**CORRIGENDUM-1**

Ref: 1. Rfs No.: 192875 Date: 09.06.2026

**Following Amendment/Addendum/Clarification is being made against Rfs No.: 192875 Date: 09.06.2026**

Indicative Drawing for Installation of Solar Home Lighting System (Standalone)

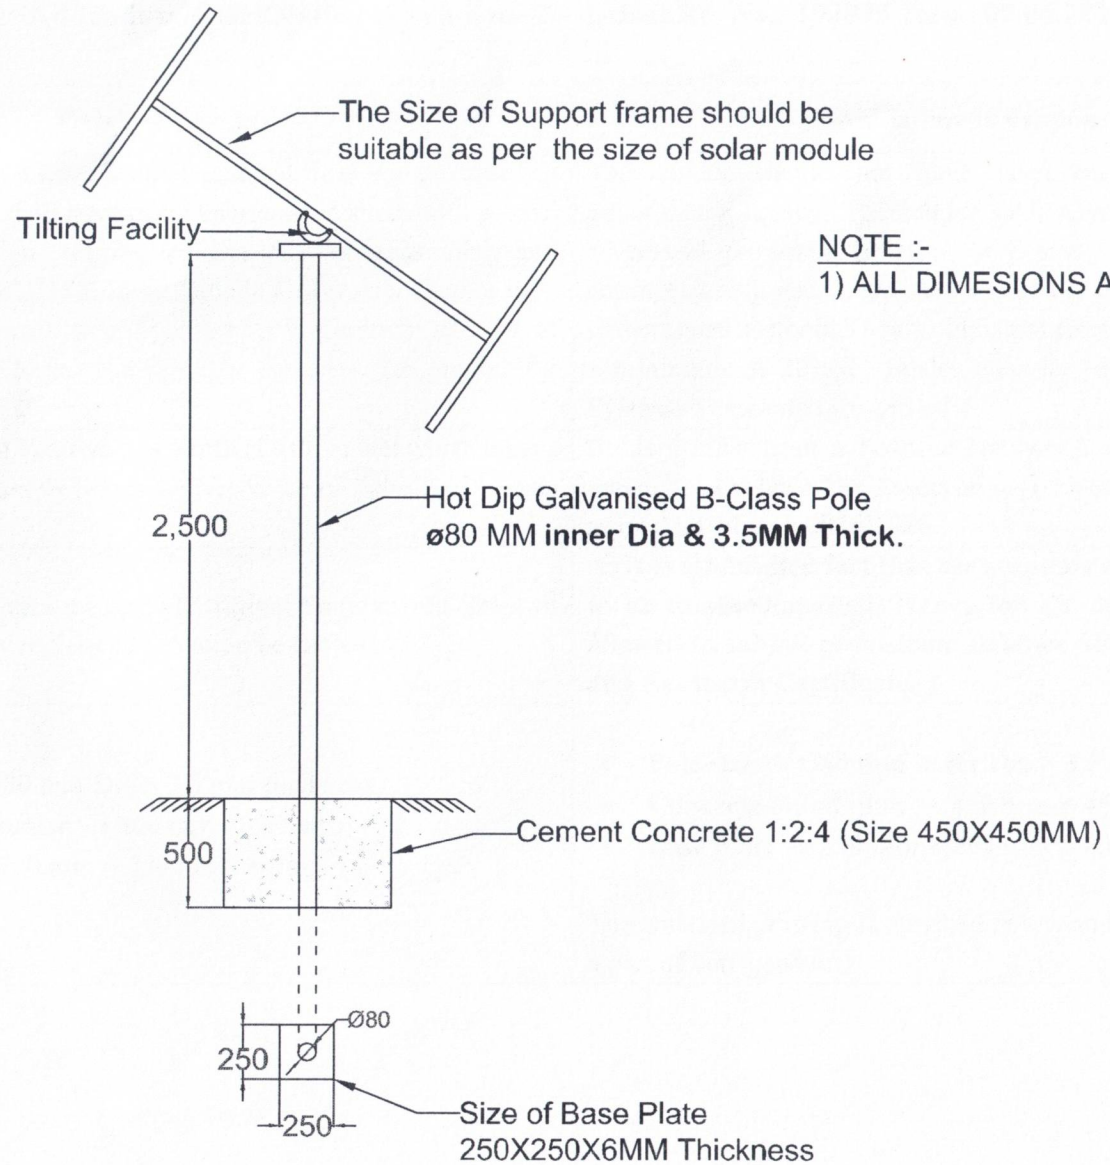
4.	Section-4 /Pg.- 27/ Drawing	<ul style="list-style-type: none"> <li>• Pole size → Ø80 mm Dia × 3.5 mm thickness</li> <li>• Concrete foundation → 800 mm × 800 mm</li> <li>• Base plate → 770 mm × 770 mm × 8 mm</li> </ul>	<ul style="list-style-type: none"> <li>• <b>Pole size → Ø80 mm inner Dia × 3.5 mm thickness</b></li> <li>• <b>Concrete foundation → 450 mm × 450 mm</b></li> <li>• <b>Base plate → 250 mm × 250 mm × 6 mm</b></li> </ul> <p>The amended drawing is attached below and to be considered as a part of corrigendum.</p>
